JOINT ARCHITECTURAL BOARD/PLAN COMMISSION AGENDA
MONDAY, NOVEMBER 20, 2017
7:00 PM
BOARD ROOM
MUNICIPAL BUILDING, 210 COTTONWOOD AVE.

MEMORANDUM

TO: Architectural Board and Plan Commission
FROM: David E. Cox, Village Administrator 
DATE: November 17, 2017
SUBJECT: Agenda Information – November 20, 2017

SHEET:
E0.2

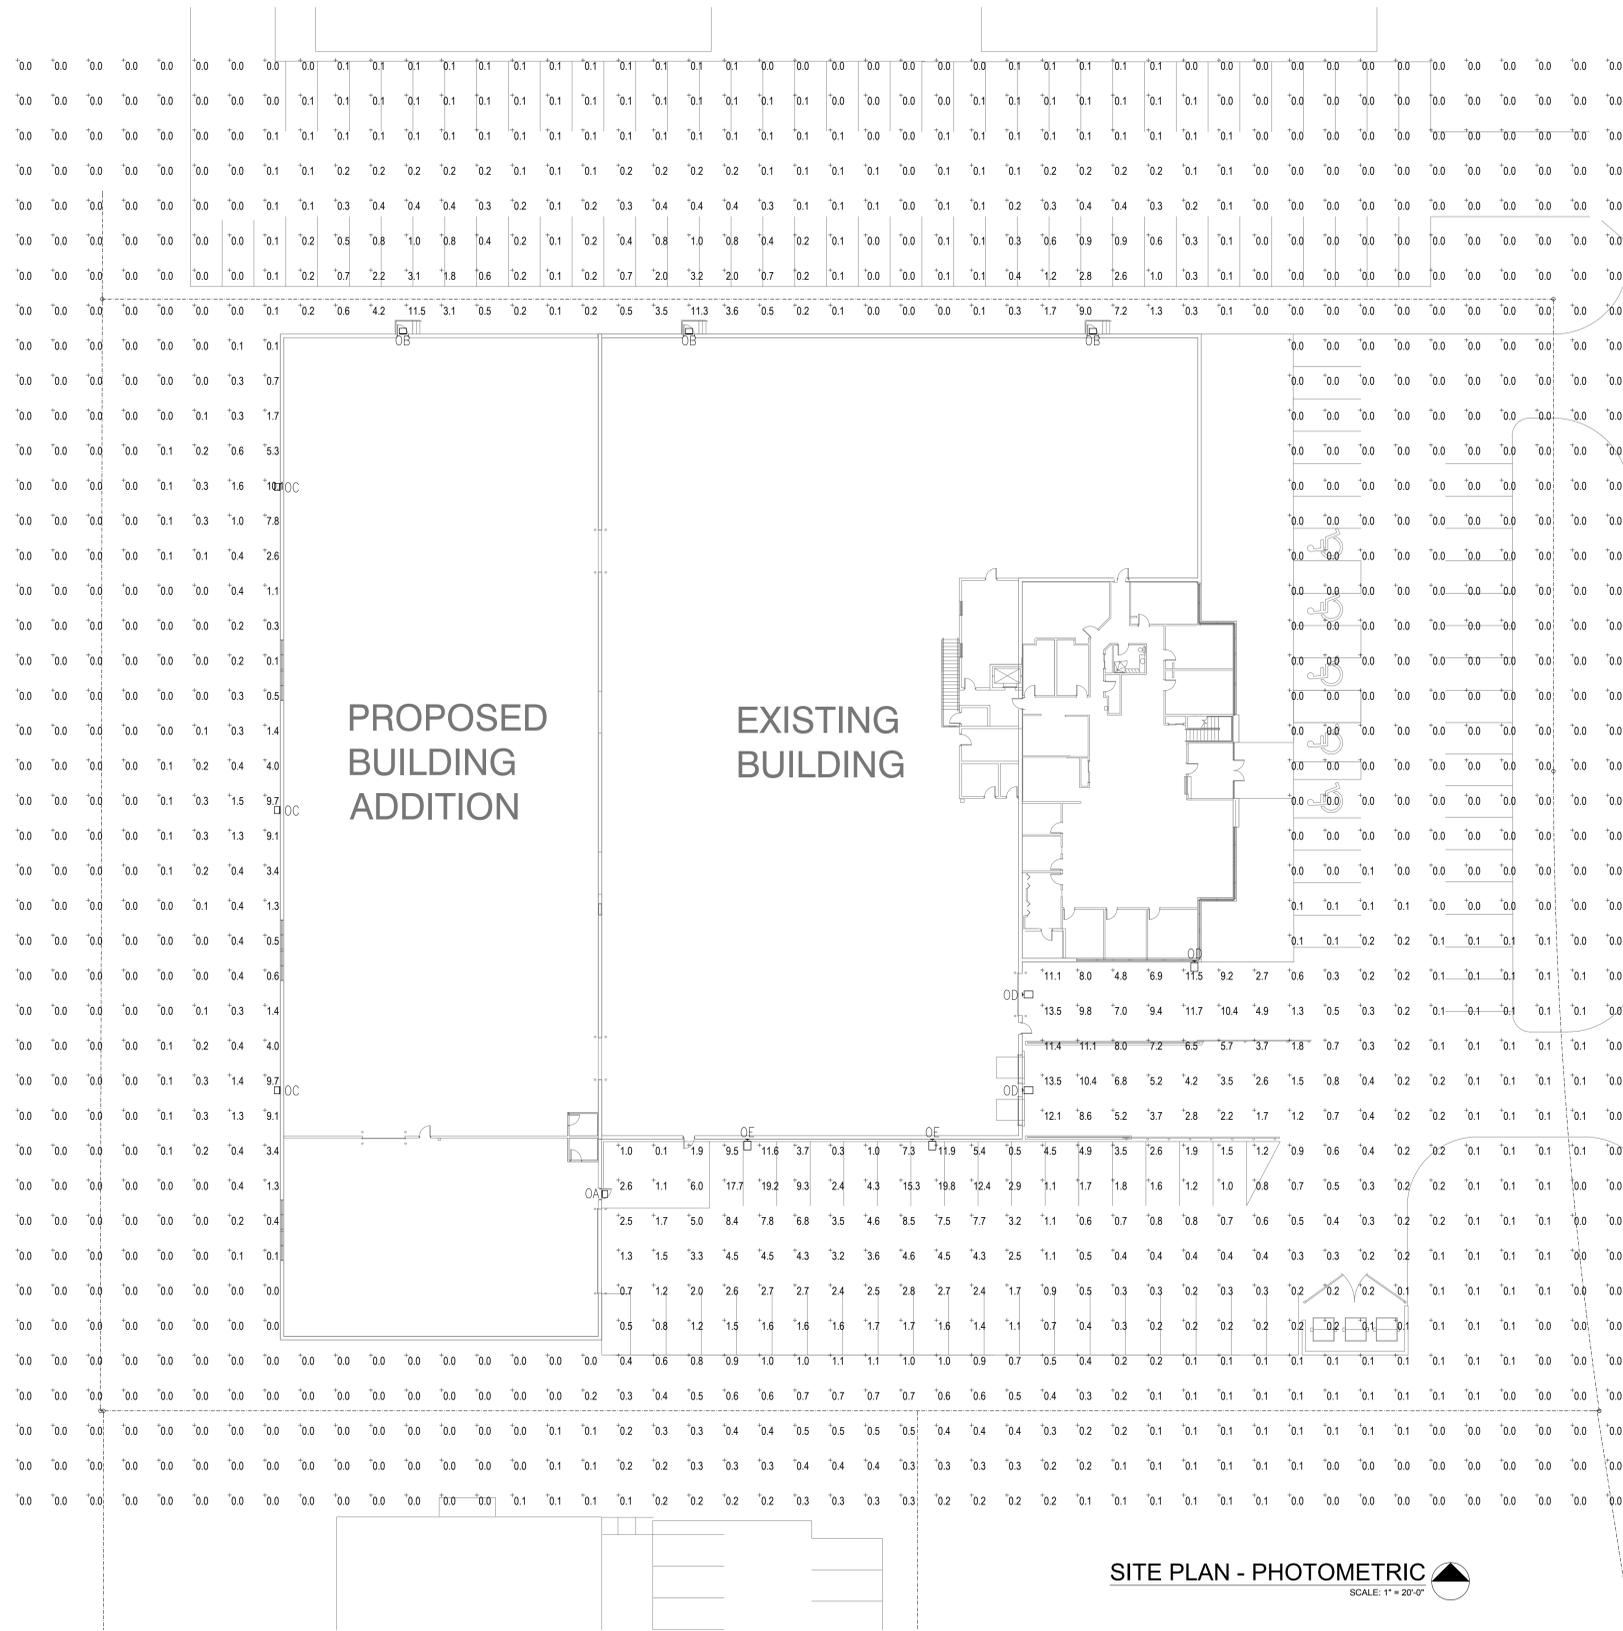
- Regarding the lighting plan, staff notes that the revised plan eliminates, or does not account for, the lighting previously dedicated to the sign.
- On the north side of the property, new lighting is being installed that will cast light onto the property to the north well above the amount allowed under the code. The neighboring property owner has indicated approval of this situation and may, in fact, benefit from the light as this portion of the neighboring lot is dedicated to parking, which also serves as overflow parking for Lake Country Racquet & Athletic Club.

The Plan Commission is requested to determine whether and how these issues will be addressed including the requirement under the Code for replacement of significant trees, the number and location of replacement trees and other landscaping and the matters of light spill over, light direction and changes in light fixture/lighting plans.

Date: 7-28-17 Drawn By: TONY ZULLI
 Sheet Title: LANDSCAPE PLAN
 Sheet Number: C-107
 Project Number: P11959
 4433

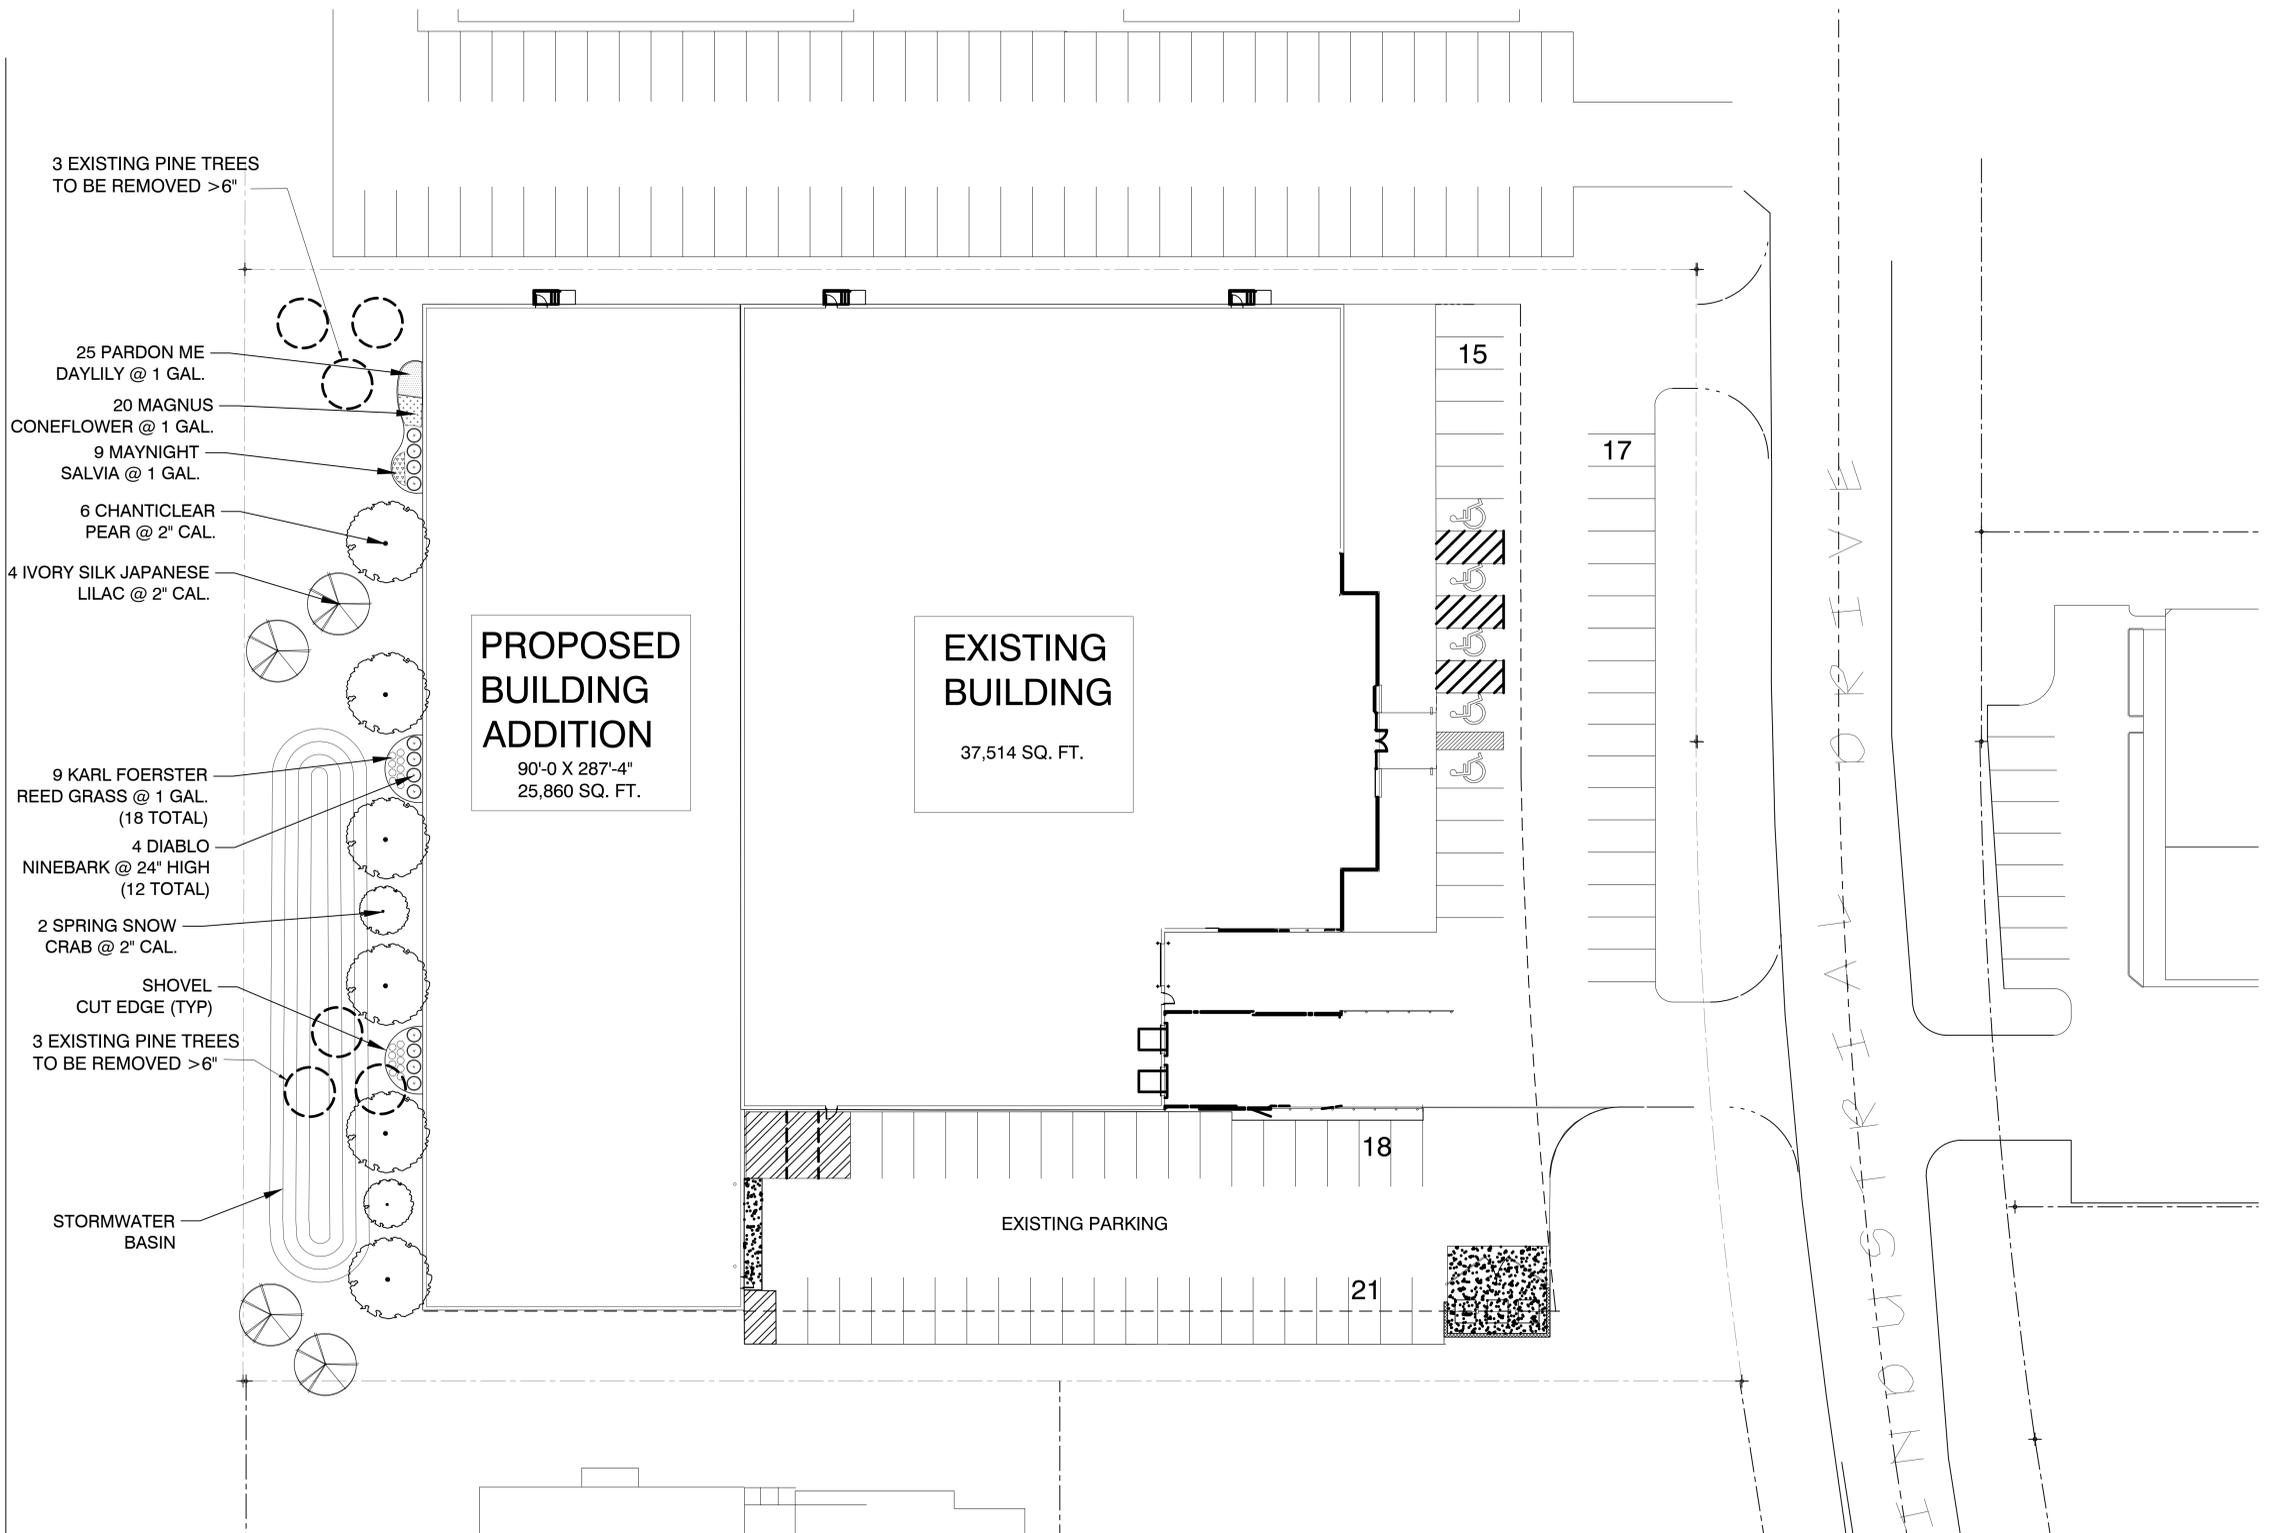
- In the revised plan and in actuality, the three remaining mature trees on the site, which were located at the north end of the lot, are/have been removed in order to provide site lines to the corporate signage. The trees were removed without advanced permission as required by the Village Code on commercial properties.

- The revised plan does not include many trees that will achieve significant size at their maturity. Trees are generally smaller and ornamental trees.
- There is a lack of evergreen (coniferous) trees in the revised plan. The original plan maintained the three mature evergreen trees at the north end of the property.

126 Condominium Units

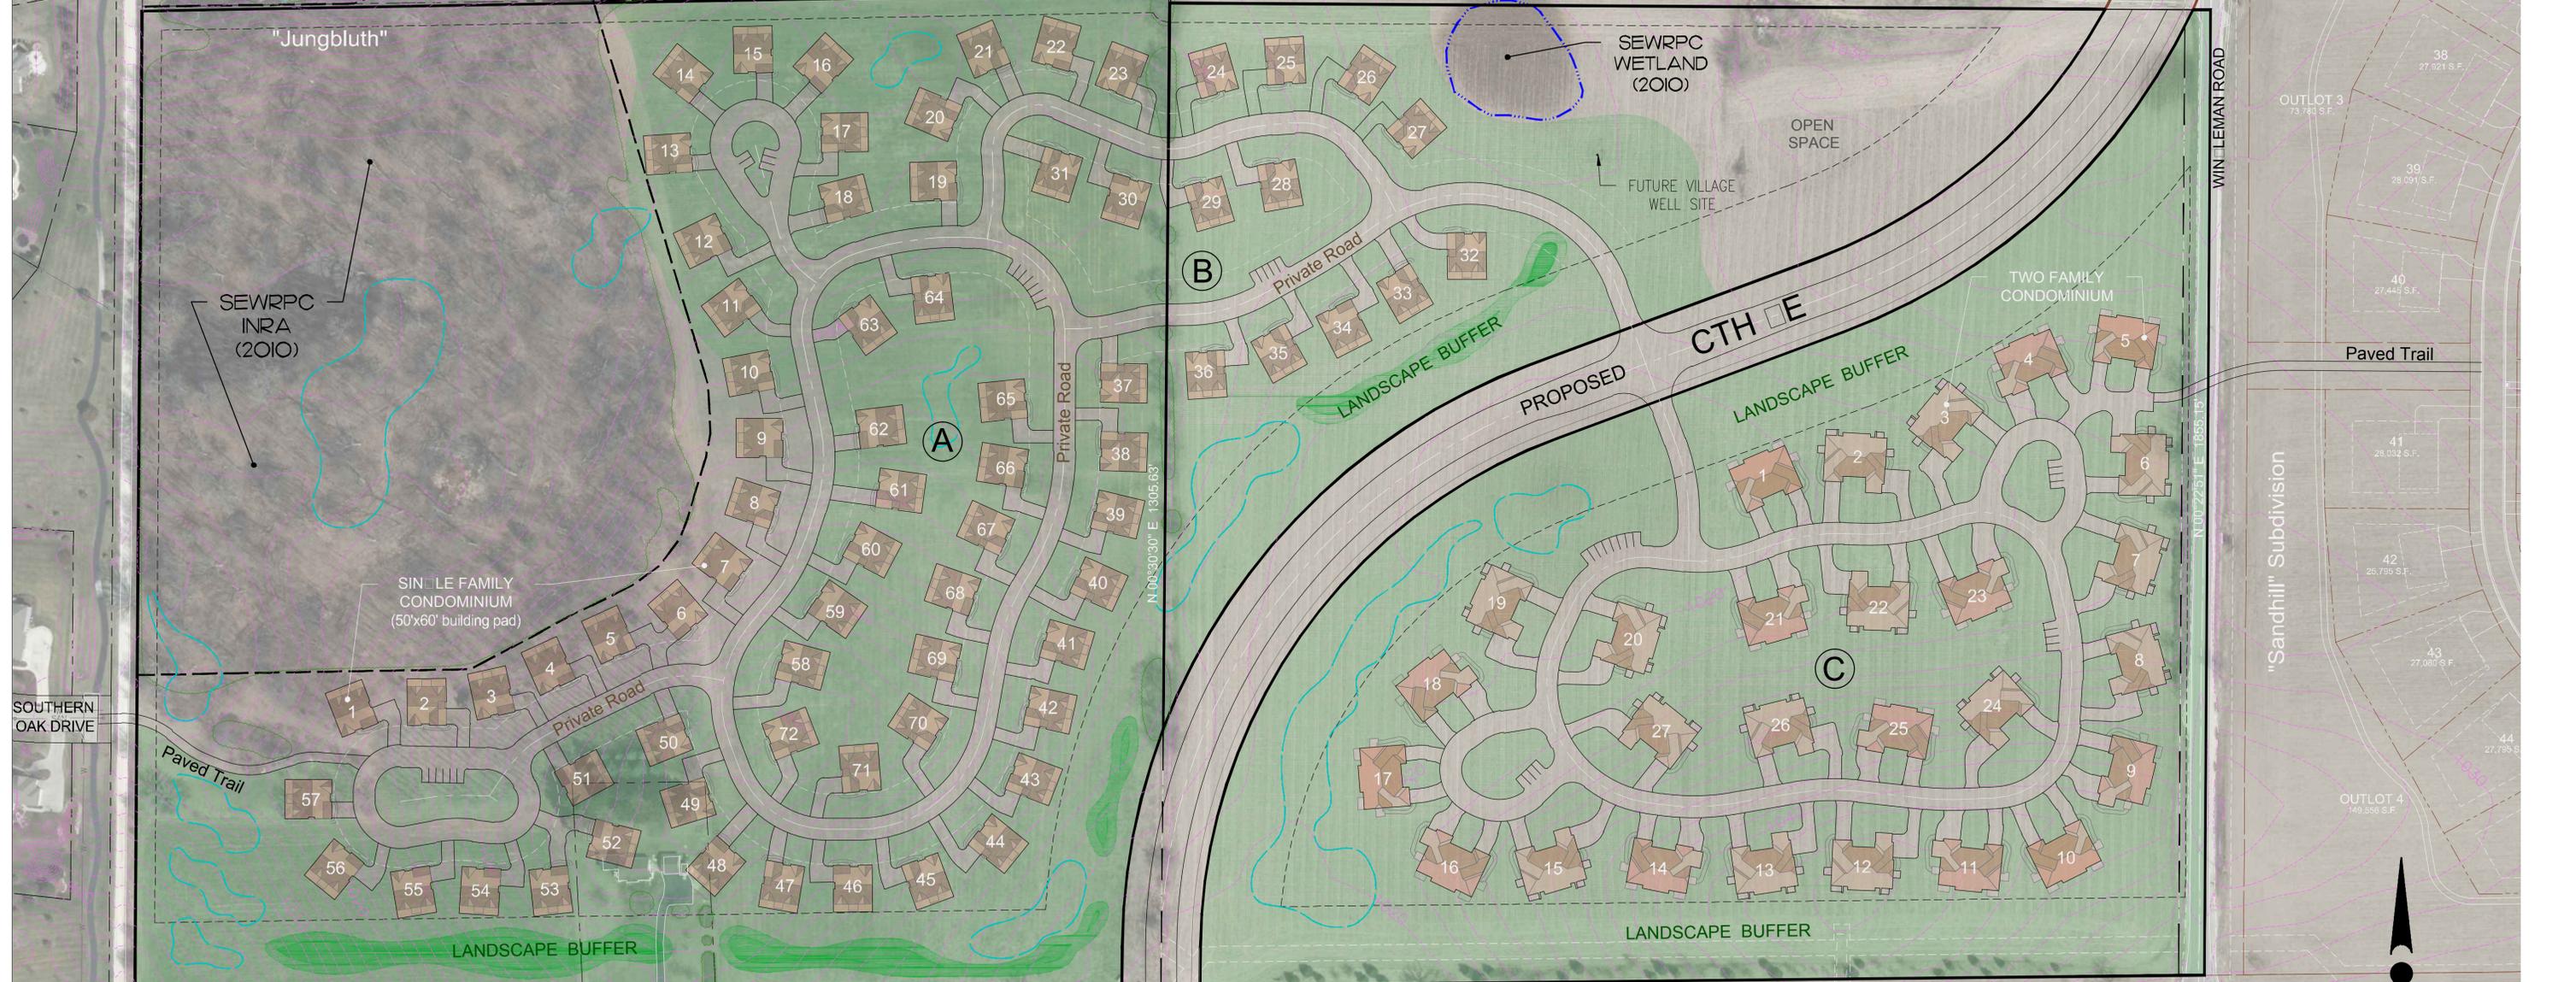
Background: The Plan Commission may recall review of a smaller version of this proposal in February and March of this year. After discussion at both meetings and a revision in between, the Commission approved a concept that called for 72 total units on the north (north of the proposed rerouted KE) and western properties (Parcels A and B) in one and two unit buildings. Based on that discussion and the known complexities of the road, Neumann has returned with a proposal that maintains the 72 units north and west of the road but all in single family buildings. In addition to that, the developer proposes 54 units in two-family buildings on the portion of the property south of the rerouted CTH KE (Parcel C). This property was conceptually approved for a portion of the Sandhill (previously Homestead) single family development by the Siepmann group.

The packet includes material and minutes from the earlier consideration so that the Commission is reminded of those discussions. The table below identifies various densities based on the parcel size calculations shown on the plan. Additionally, based on the Village definition of Net Density, staff has removed an estimated 1.7 acres from the size of parcel AB based on the 3,700 foot roadway length indicated on the plan multiplied by a 20-foot wide roadway and an estimated .85 acres from parcel C to account for an estimated 1,850 feet of roadway (50% of 3,700).
